## **Planned Change Request for Shielded Containers**

### **Summary**

The U.S. Department of Energy (DOE) is proposing to package and emplace a portion of the Remote Handled (RH) Transuranic (TRU) Waste inventory in shielded containers at the Waste Isolation Pilot Plant. The use of the shielded containers will enable DOE to expedite the cleanup of various TRU waste sites by significantly increasing the rate at which portions of the RH TRU waste can be received and emplaced at the WIPP. The shielded containers will be transported to WIPP in the HalfPACT transportation container. The shielded containers will be managed and emplaced in the rooms of the repository in a fashion similar to what is currently used for Contact Handled (CH) TRU waste. The robustness of the containers has been demonstrated by passing the Department of Transportation (DOT) 7A Type A and the Nuclear Regulatory Commission (NRC) Type B drop tests and are awaiting regulatory approval.

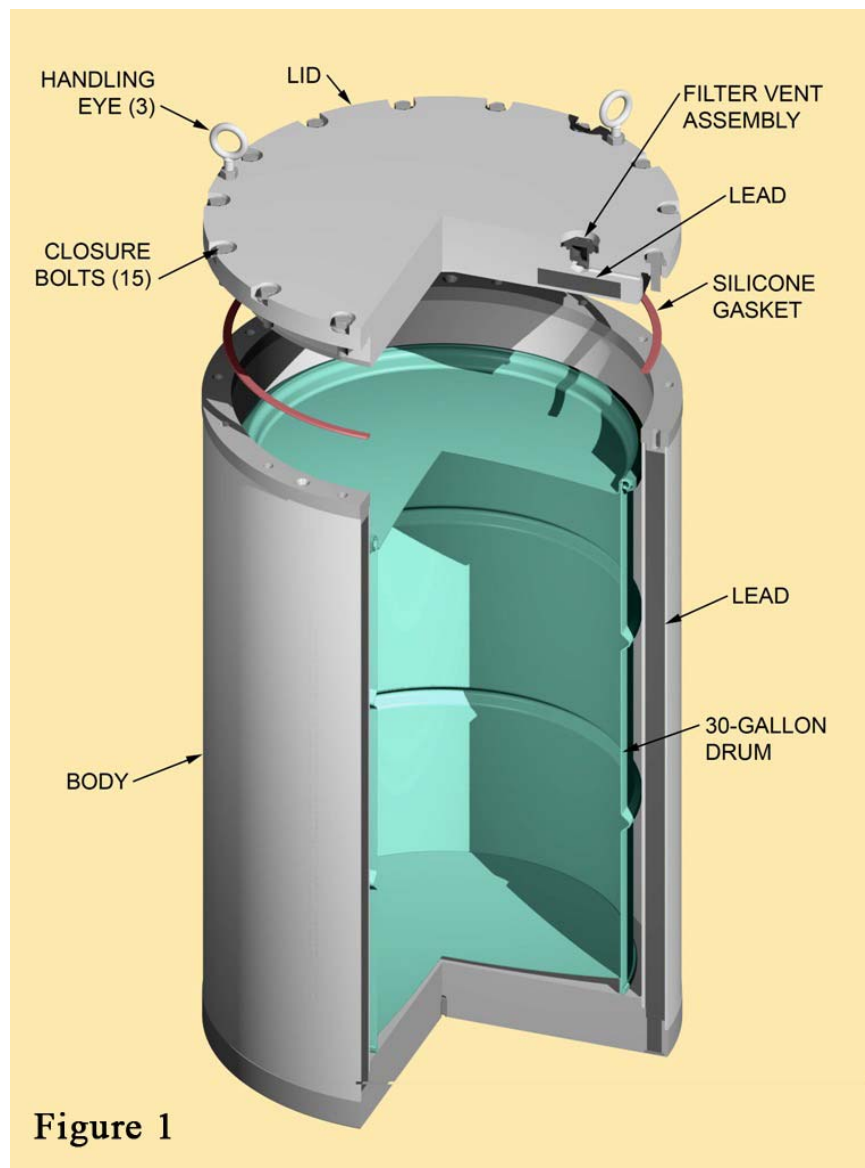
The shielded container has approximately the same exterior dimensions as a 55-gallon drum and is designed to hold a 30-gallon drum. The cylindrical sidewall of the shielded container has 1-inch thick lead shielding sandwiched between a double-walled steel shell as shown in Figure 1. The external wall is 1/8 inch thick, and the internal wall has a thickness of 3/16 inch. The lid and the bottom of the container are made of carbon steel and are 3-in thick. The empty weight of the containers is approximately 1,800 pounds. The shielded container and the inner 30-gallon drum will be vented. The container has been tested to DOT Type 7A and NRC Type B Hypothetical Accident Conditions (HAC) specifications. This will ensure the container is safe for transport and handling and will contain and shield the waste under the most severe accident conditions.

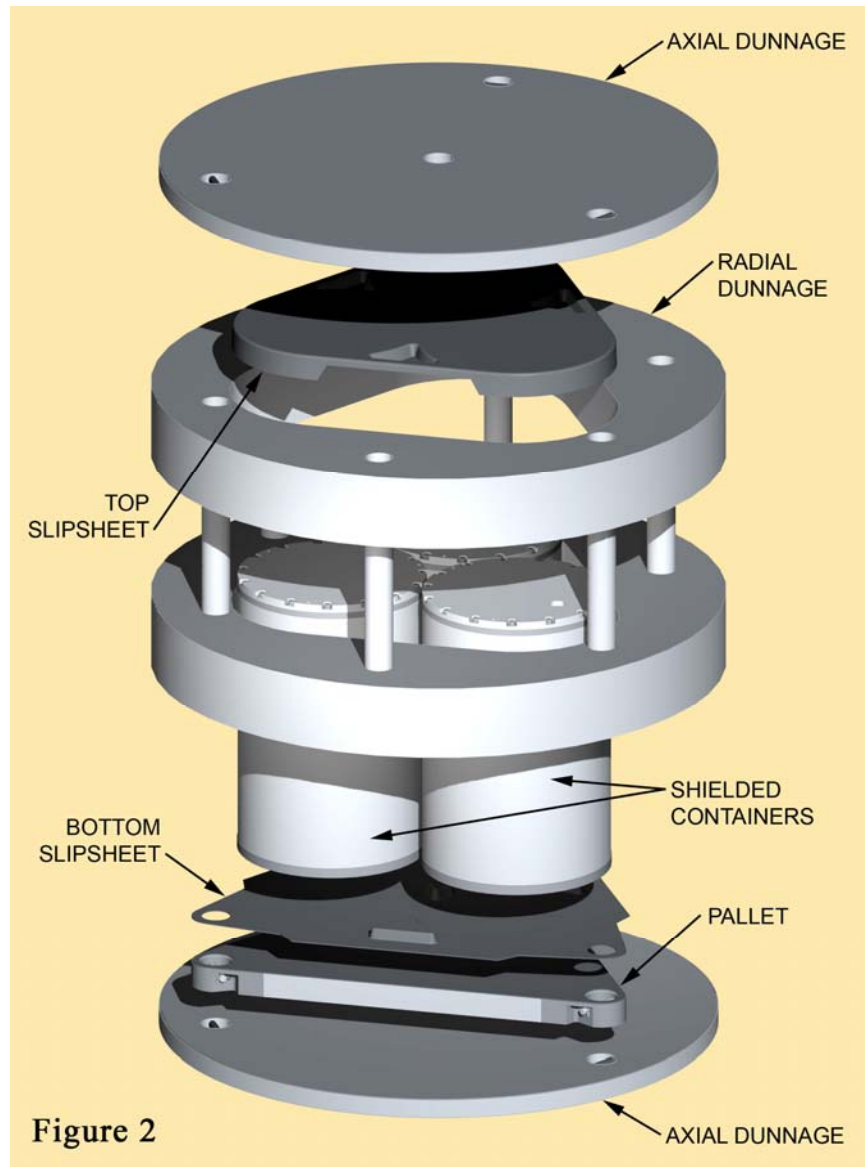
The shielded containers will be assembled in a 3-pack configuration on a triangular pallet, be surrounded by radial and axial dunnage components, and be transported within the existing HalfPACT transportation container. The 3-pack configuration will remain intact throughout transportation and emplacement (Figure 2). The shielded container is designed to stay within the parameters of the HalfPACT design and licensing bases e.g., payload weight, decay heat and radiation dose rate limits. To ensure the robustness of the container, it was subjected to DOT 7A Type A testing that included 4 foot drops of the bare container onto an unyielding surface using four potentially worse-case orientations. As part of the safety analysis, a 3-pack of containers was drop tested 30-feet inside a HalfPACT ICV (Inner Containment Vessel) as part of the Hypothetical Accident Condition (HAC) evaluation required by Title 10 CFR Part 71. The HAC tests evaluate and ensure the containers will adequately shield the RH TRU waste contained within under the most severe accident conditions. The thermal, shielding and criticality evaluations were performed by analysis using similar methodology as presented in the HalfPACT Safety Analysis Report (SAR), RH-TRU 72-B SAR and the TRUPACT II SAR. The tests were successful and the results will be used to demonstrate compliance with all applicable DOT and NRC standards, ultimately leading to certification of the payload container as a DOT 7A, Type A container and as an authorized payload container for shipment within the NRC certified HalfPACT Type B Packaging. DOE is awaiting regulatory approval. The success of this testing proved the container is safe even after being subjected to worst case severe handling or accident condition impacts as specified within the DOT and NRC regulations.
